SUBJECT: TRANSMITTAL LETTER FOR SWMU 0-017 SAP

**SAMPLING AND ANALYSIS PLAN
FOR
THE RCRA FACILITY INVESTIGATION AT
SOLID WASTE MANAGEMENT UNIT 0-017
WASTE LINES 170 AND 171**

**SUBJECT: RESPONSE TO RSI ON THE SAP FOR PRS 0-017
(FORMER OU1071 FU 1)**

**Response to
Request for Supplemental Information
SAP for Solid Waste Management Unit**

Figure 3.2.3.2-1 Cross section view of pipeline in Los Alamos Canyon showing proposed sampling locations for a portion of PRS 0-017.

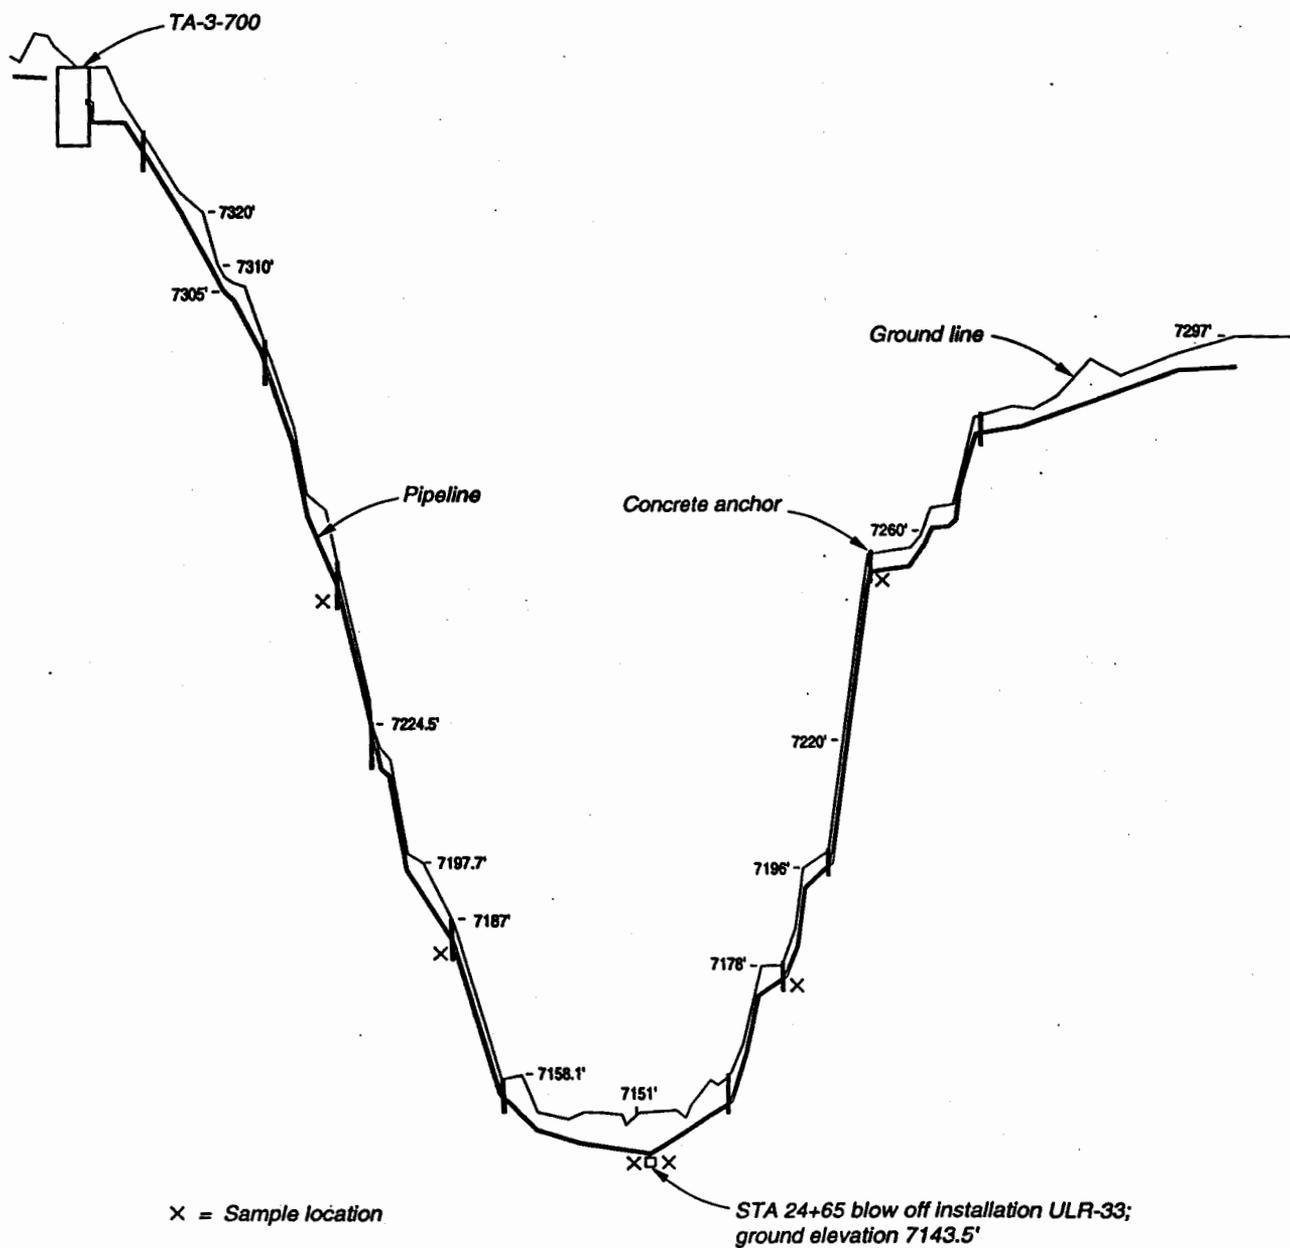
Provide rationale for the statement in paragraph 2 which says that ULR-33 does not represent a more likely point of release if its intended purpose was to drain into Los Alamos canyon or provide documentation showing that it was never used for this purpose.

Field screening technologies such as field portable X-ray fluorescence may be useful in identifying potential contamination and citing an appropriate number of boreholes.

9. The subject statement is speculative and will be removed. Documentation regarding the use of ULR-33 cannot be provided. ULR-33 was removed as part of the Acid Waste Line Removal Project, along with Line 167

Radiological surveys will be used to make determinations on location and depth of borings and/or sampling locations.
